Amendment Notice 2

Licence Number	L9099/2017/1
Licence Holder	Kundana Gold Pty Ltd
ACN	099 643 252
File Number:	DER2017/001616
Premises	M16/548 Carbine/Paradigm Project Area Mount Burges Shire of Coolgardie
Date of Amendment	28 March 2019

On 8 October 2018 Kundana submitted an application to discharge mine dewater into the nearby Phantom pit to provide additional water storage for current and future operations. To enable this the following activities are proposed:

Schedule 1: Site plan map

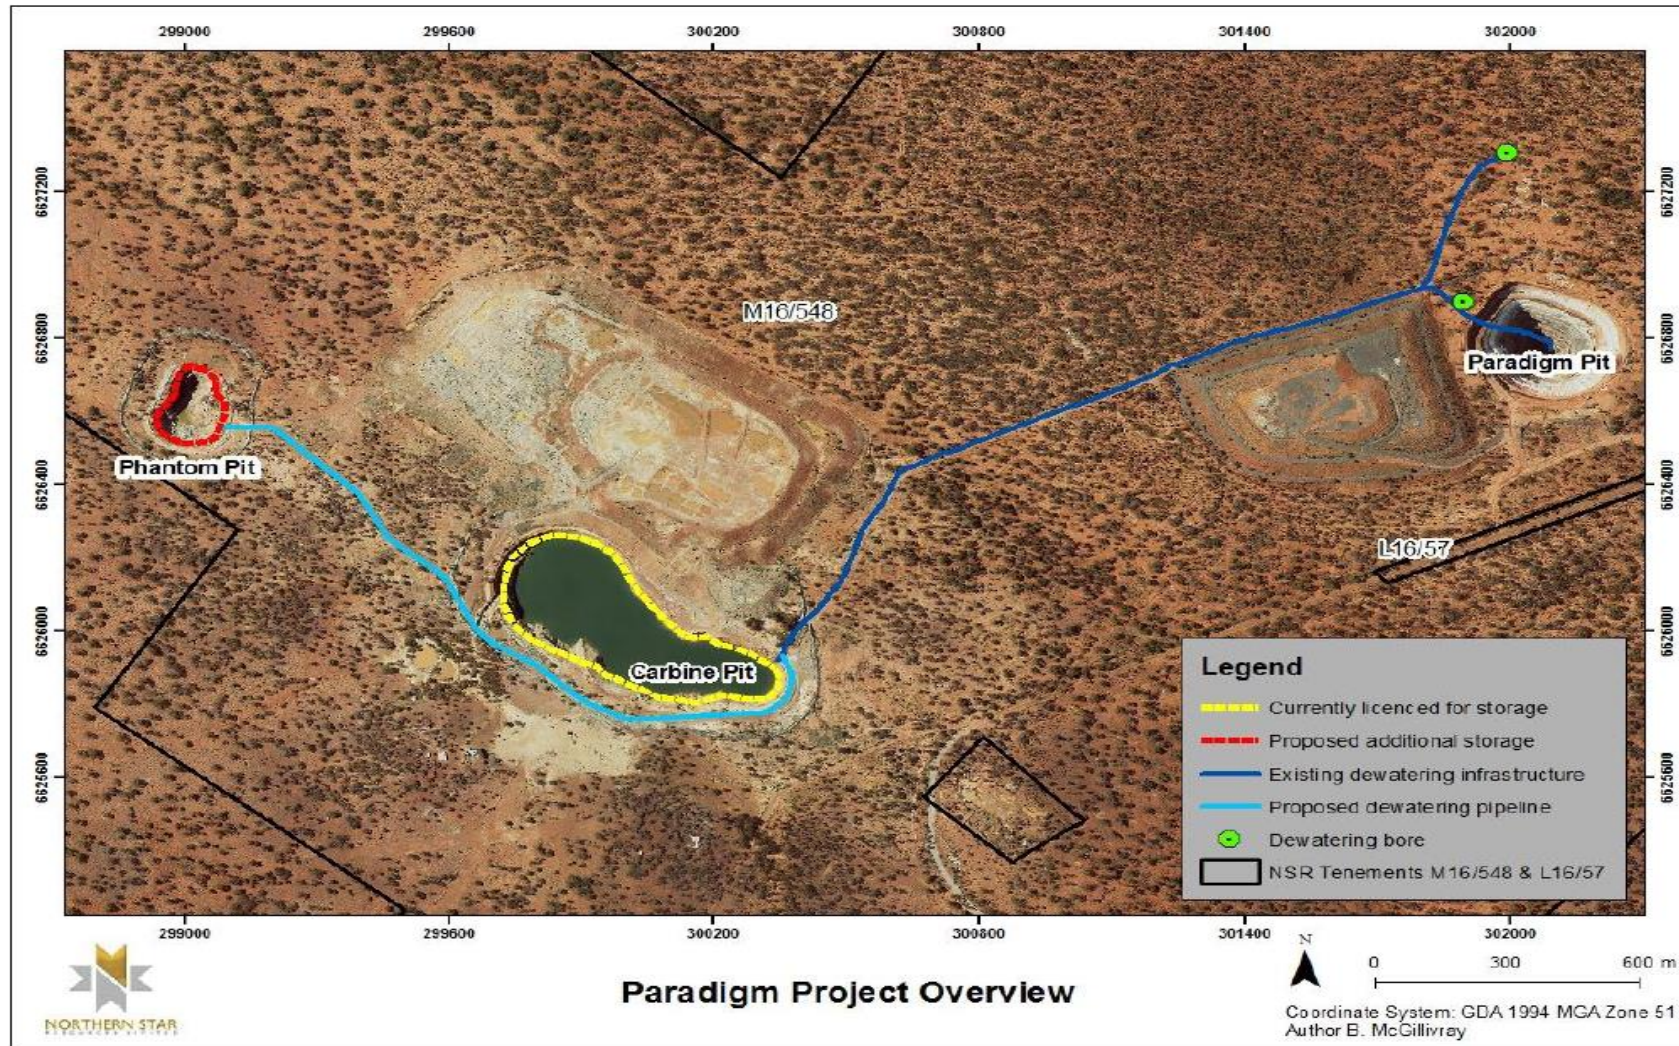
- Condition 2 Table 3: Infrastructure and equipment controls is amended to clarify the location and source of dewatering pipelines.
- Schedule 1: Maps Site plan map is amended to include the additional line.
- The annual reporting period is amended from 1 December to 30 November to 1 January to 31 December; and
- The reporting deadline is amended to within 90 days after the end of the annual reporting period.

5. The Licence is amended by the deletion of the Site plan map and the insertion of the Site Plan map shown below:
